Proposal for amendments to Regulation No. 55 (Mechanical couplings)

A. PROPOSAL

Sketch to determine the minimum length of
the "Secondary coupling device" add. ECE R55

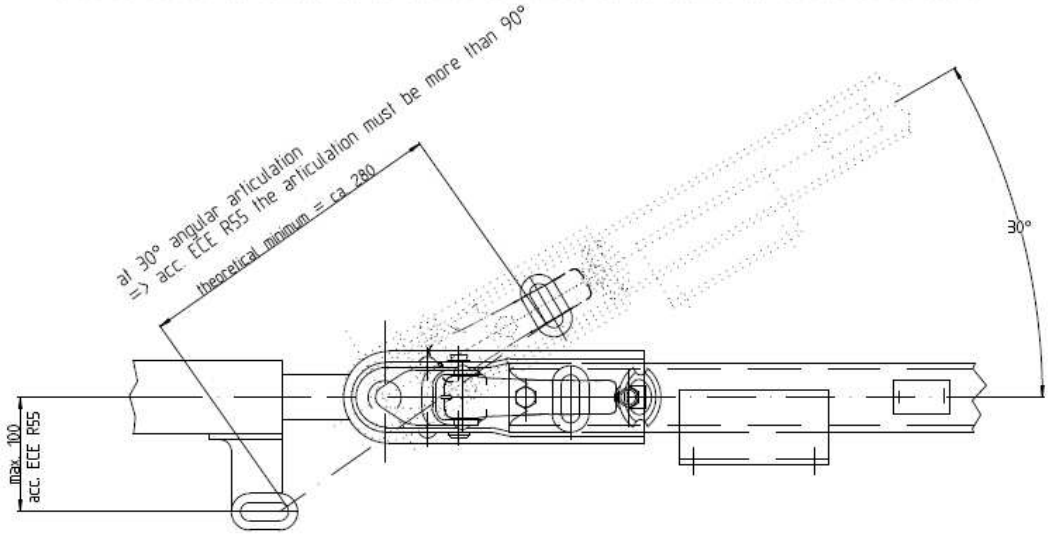
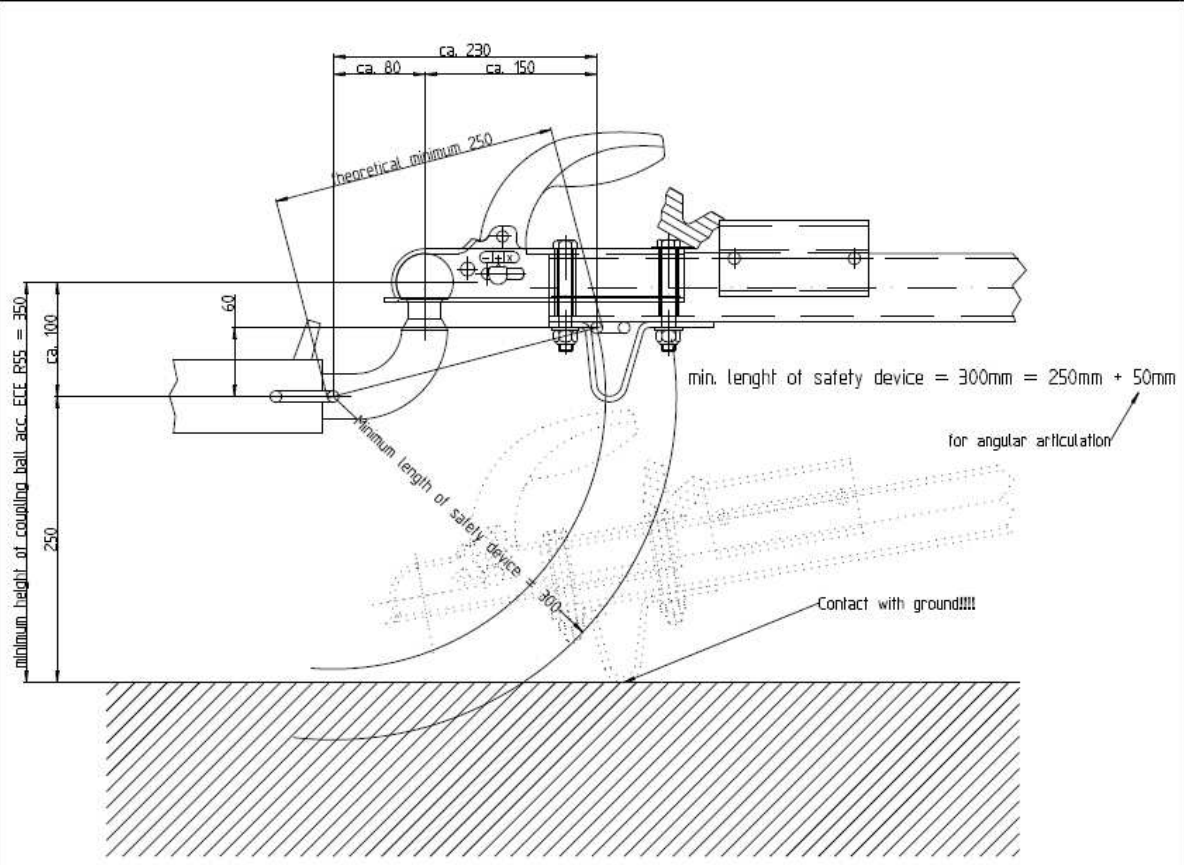
Plus extra 60mm for difference in height (siehe view above)
=> resulting minimum length of safety device = 300mm

Sketch to determine the minimum length of the "Secondary coupling device" add. ISO/CD 12385

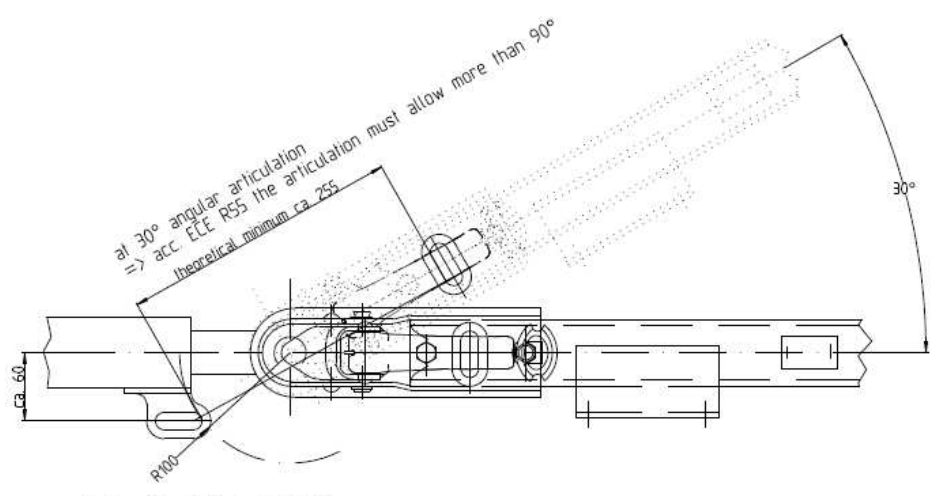
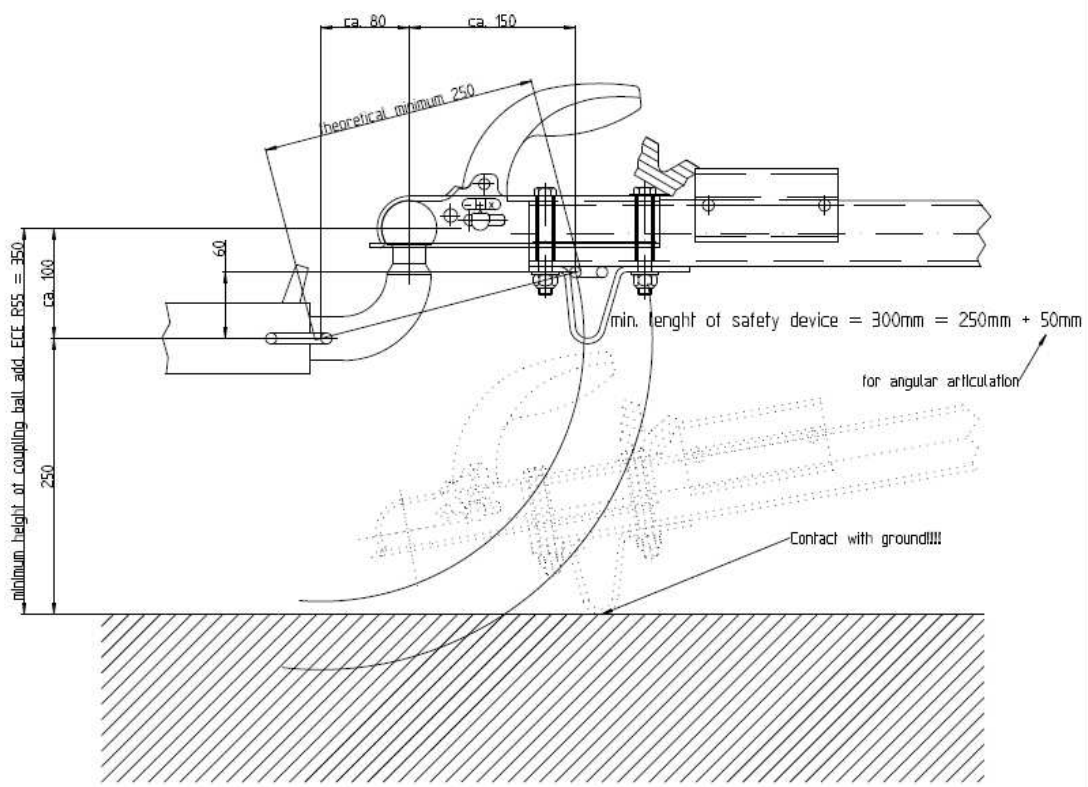
fixing point within a radi R100
acc. figure B.2 of ISO/CD 12385

Plus extra 60mm for difference in height (siehe view above)
=> resulting minimum length of safety device = 300mm
